DESCRIPTIVE REPORT

Registry No. H11271

General Locality Approaches to Sitka

Sublocality Vicinity of Vitskari Rocks

Figure 2. Inaccurate Sound Velocity Resulting in "Frowns" VN 1021 DN126

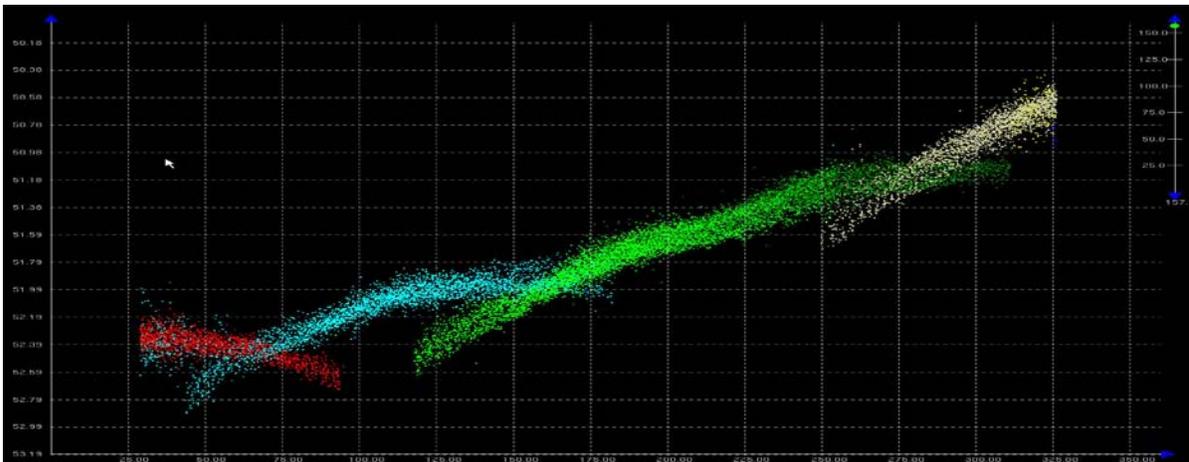
Very minor sound speed correction errors are present in the dataset. Although not visible in the BASE surface, examination of bathymetry in subset mode reveals the characteristic "frowns" indicative of inaccurate sound velocity corrections. The example in Figure 2 below is typical, with error of ~0.2m in 50m of water. The hydrographer considers these errors negligible and within the allowed error budget for this depth.¹¹

¹¹ Concur. All correctors are adequate. All bathymetry submitted for H11271 is acceptable for charting and is adequate to supersede prior survey data within the common area.
